W3F1-97-0107  
A4.05  
PR

Subject: Waterford 3 SES  
Docket No. 50-382  
License No. NPF-38  
Actions to Resolve Issues Concerning Air Operated  
Containment Isolation Valves

## Actions to Resolve Issues Concerning Air Operated Containment Isolation Valves

# Proposed Alternate Fill for Containment Isolation Valves DC 3429

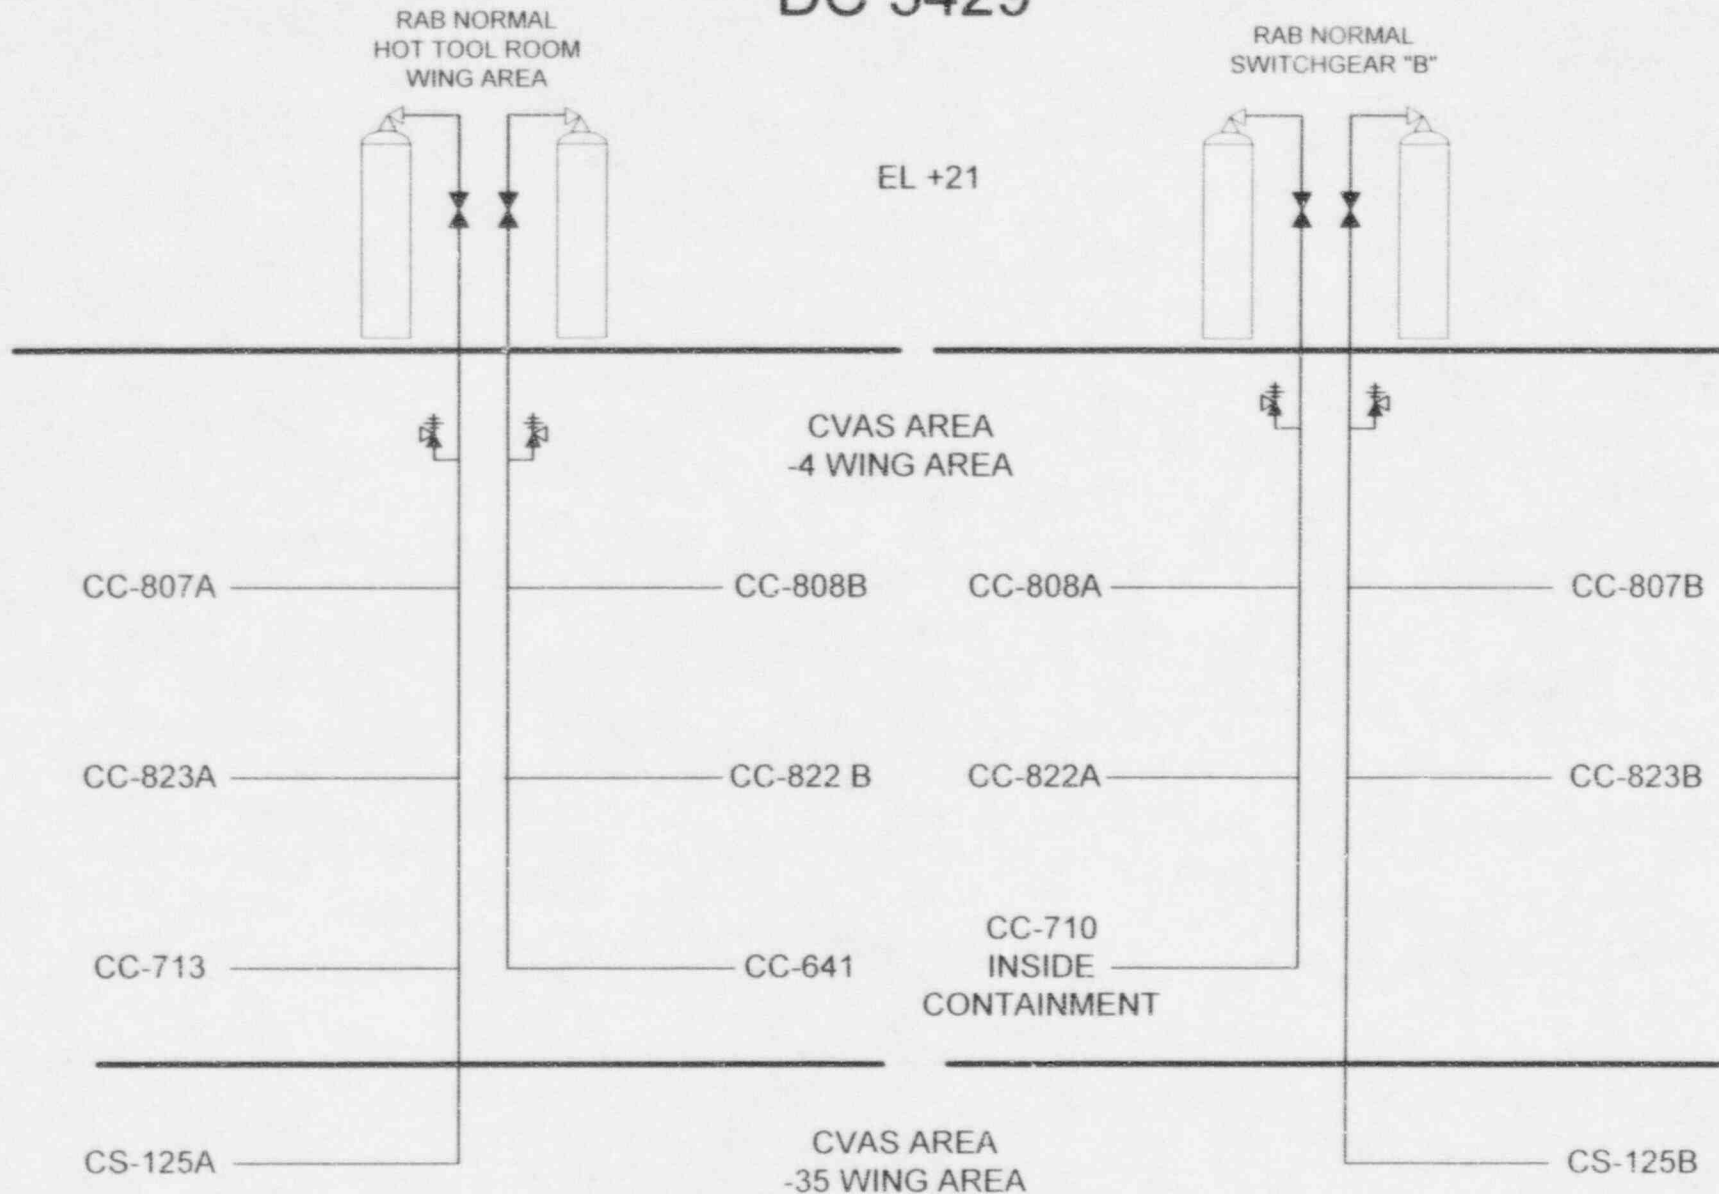
**Short Term Actions (Excluding Penetration 27 Charging)** - Design Change 3429 will implement a safety related system to provide motive gas to the accumulators for the valves listed above (excluding CVC-209).

These valves do not have the motive power to assure closure for the duration of a postulated accident that assumes the loss of instrument air. The accumulators for each valve are sized for 2 strokes, 10 hours (with the exception of CS-125A/B) accumulators that are rated for 6 hours) post accident. This time is not sufficient for post accident containment isolation, which is postulated to be a total of 30 days.

DC 3429 will install safety related tubing and valves under the provisions of 10 CFR 50.59 to provide a backup source of nitrogen gas, if instrument air is unavailable, to the accumulators for each of the valves (excluding CVC-209). DC 3429 will provide the required 30 day closure capability.

A set of nitrogen bottles will be installed on EL +21 level in the RAB which is a low dose area expected to be accessible at all times during and after an accident. The location of the nitrogen bottles will be just above the set of valves it will serve.

CCW to CFC containment isolation valves and CCW RCP containment isolation valves are located on EL -4 level in the RAB wing area. The CS (CS-125) containment isolation valves are located on EL -35 level, also in the RAB wing area, just below the valves on the -4 wing area. Enclosure 1 provides a basic flow diagram.

All tubing and valves will be installed to ASME Section III, Code Class 3. The nitrogen bottles will be standard gas cylinders, and will be dedicated safety related for this use. All equipment will be installed Seismic Category I.

**CHEMICAL and VOLUME CONTROL - CHARGING SYSTEM  
PENETRATION 27  
(SIAS/No RAS Alignment Shown)**

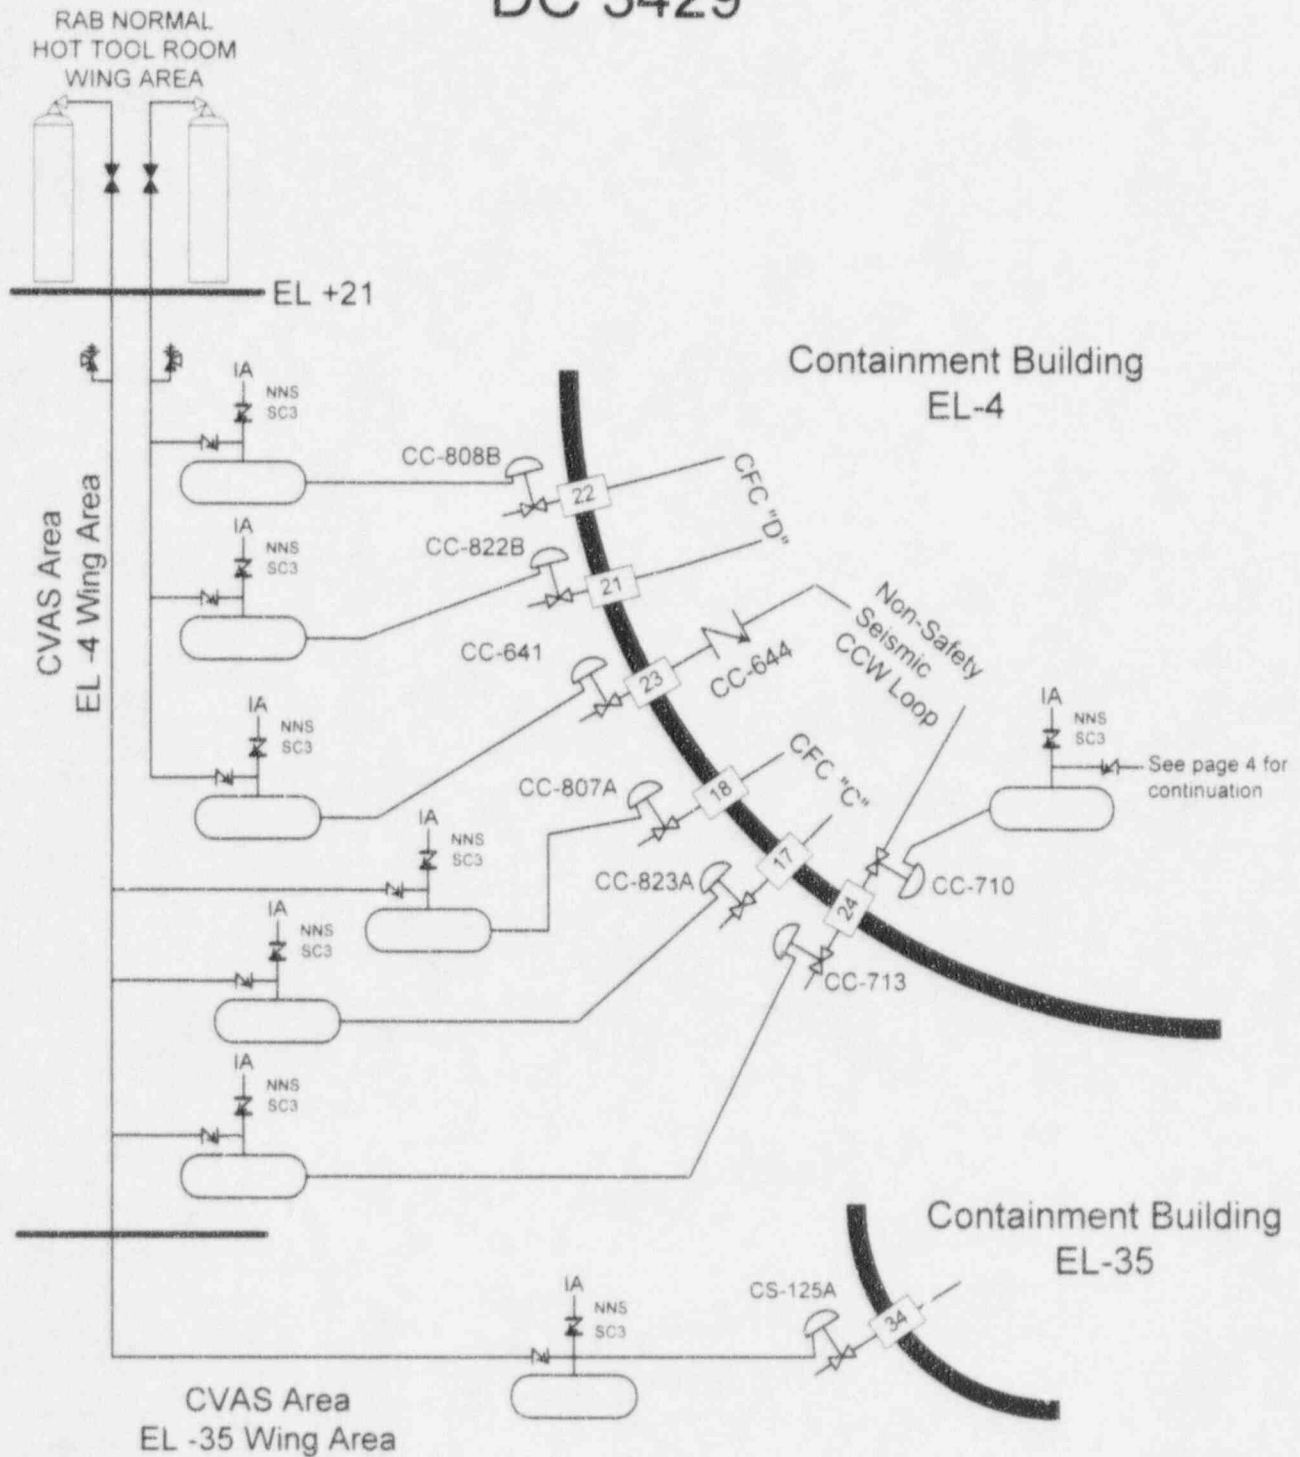
**Short Term Action for Penetration 27 Charging** - The outside containment isolation valve in the Charging line is an air operated gate valve. This valve is not equipped with an air accumulator and the solenoid in the air supply to the actuator is not Class 1E. The position indication for this valve is also not Class 1E. The valve is designed to fail open, its normal position is locked open and the post-accident position is open. Additional barriers included in the Charging line up stream of the outside containment isolation valve are, a normally open manual valve (CVC-208), Charging pump discharge check valve (CVC-194A, A/B, B), a positive displacement pump, RWSP to Charging suction check valve (CVC-508) and RWSP to Charging suction isolation motor operated valve (CVC-507).

For Fuel Cycle 9 Waterford 3 will credit closure of CVC-208 in the event containment isolation valve CVC-209 is not able to perform the closed safety function. CVC-208 is a reach-rod operated valve, equipped with local mechanical position indication and located approximately 3 feet upstream of CVC-209 (see attached Enclosure 2). The valve and associated piping is Seismic Category I, Safety Class 2 and the valve remote operator is located on EL +21 level in the RAB switchgear area. This area is a low radiation dose area expected to be accessible at all times during and following an accident. As previously stated, the valve would be capable of being closed in less than 10 minutes from the point at which the control room recognizes the need to isolate the penetration. The administrative controls provided in the Emergency Engineering Resource Guide will also describe instructions to isolate penetration 27 if required.

**Long Term Actions Penetration 27 Charging** - The following long term actions will be implemented for CVC-209 during Refueling Outage (RF) 9 or an outage prior to RF9 of sufficient duration following development of the design change (DC 3529) currently scheduled for June 1998. This time duration will allow for final project scoping, material lead time and modification package development. DC 3529 will include:

- 30 day closure capability
- Class 1E power
- Remote position indication pursuant to RG 1.97
